MEMO

SUBJECT: Response to HMMH Gales Ferry sound peer review

Thank you for forwarding to me HMMH's November 10, 2024 peer review of RSG's "Cashman Gales Ferry Intermodal, LLC Industrial Regrading Sound Study." While the peer review found that the RSG report was comprehensive and largely conservative, there are several issues HMMH noted that I respond to in this memo.

FIGURE 2: SOUND CONTOURS FOR THE BEGINNING OF EXCAVATION

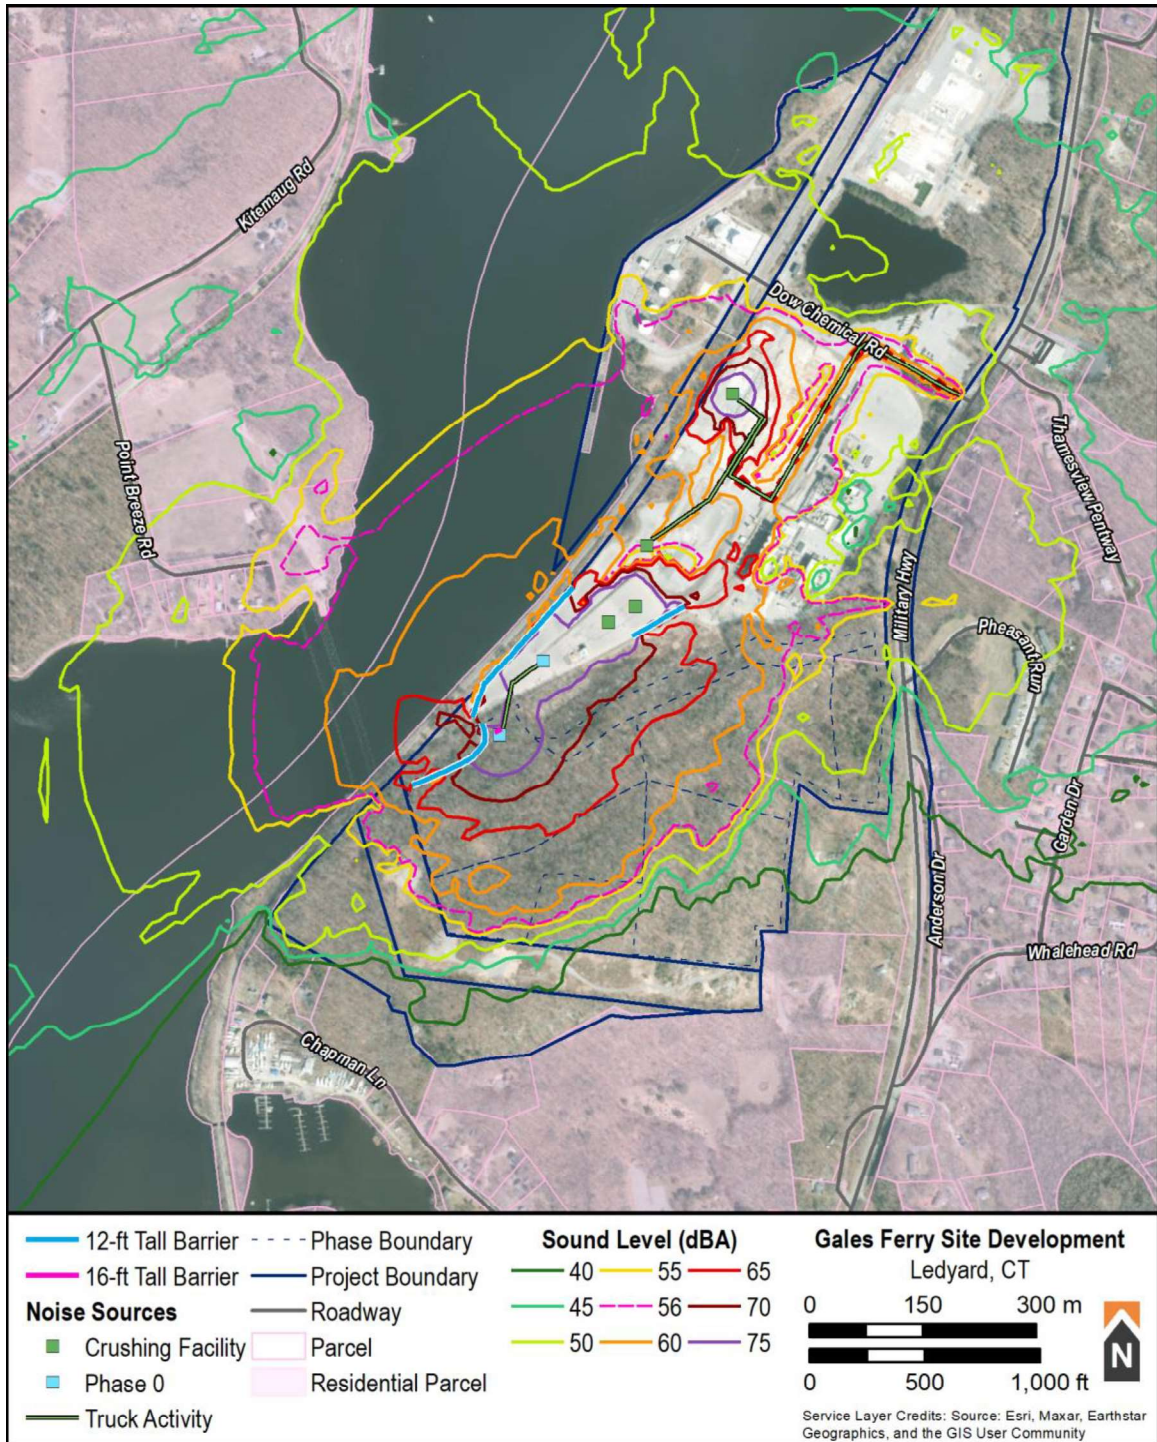
HMMH suggested that, while 61 dBA is the applicable noise limit, there should be a 5 dB buffer to take into account a modeling margin of error and variability in equipment sound emissions. This would make the modeling design goal 56 dBA on any residential property.

HMMH noted that the project could be very audible and “very intrusive for a considerable period of time.” They recommended a noise limit based on the background L₉₀ plus 5 dB.

With these mitigation measures in place, we updated the sound propagation modeling. The results, shown in Table 2 and Figures 2 through 8, indicate that the sound levels modeled at all residential properties and residences are at or below the requested design goal of 56 dBA. The highest modeled sound level at a residence in Ledyard is 55 dBA during Phase 2, and 52 to 54 dBA during the remaining phases.

FIGURE 8: SOUND CONTOURS FOR PHASE 5

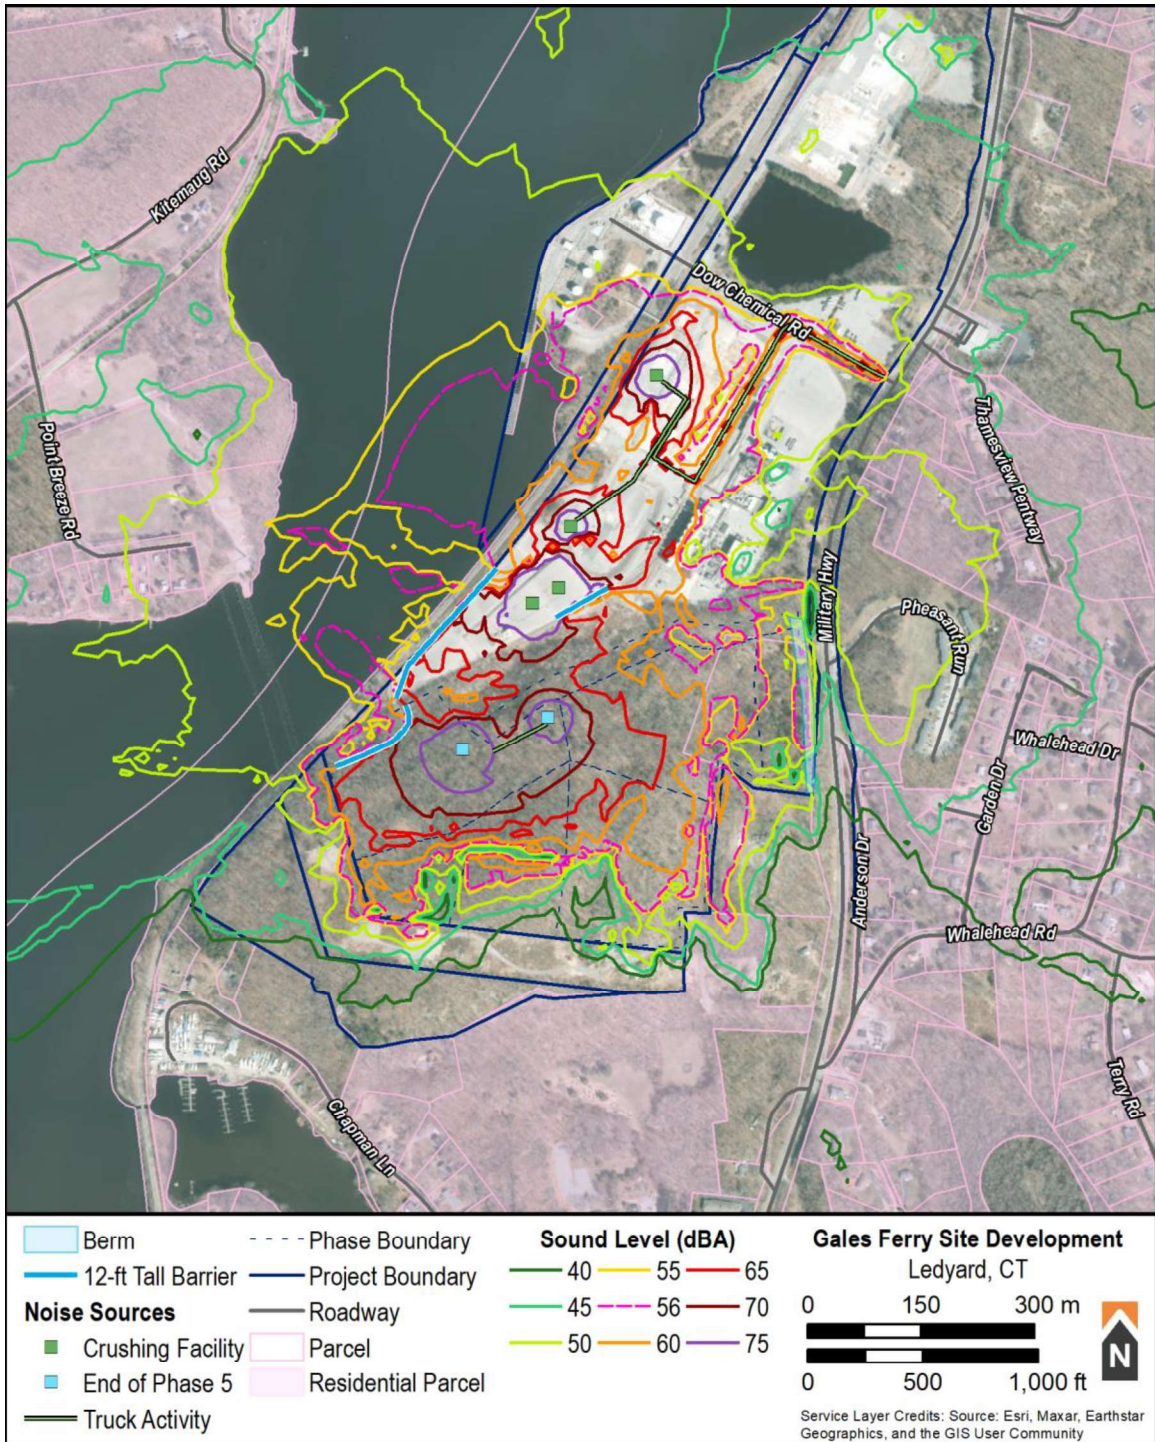
HMMH noted that the sound level was 61 dBA on the residential parcel on Pheasant Run during Phase 5 of the project. We respond that the sound level from the project does not exceed 61 dBA, so the project is modeled in compliance would the Connecticut regulatory noise limit.

Nevertheless, RSG reviewed Phase 5 of the project with the applicant. The applicant has agreed that no drilling or blasting would occur during this phase. This results in a substantive decrease in sound from the project. The highest project sound levels for this phase drops from 61 dBA to 54 dBA for any Ledyard residential parcel and to 51 dBA at any Ledyard residence.
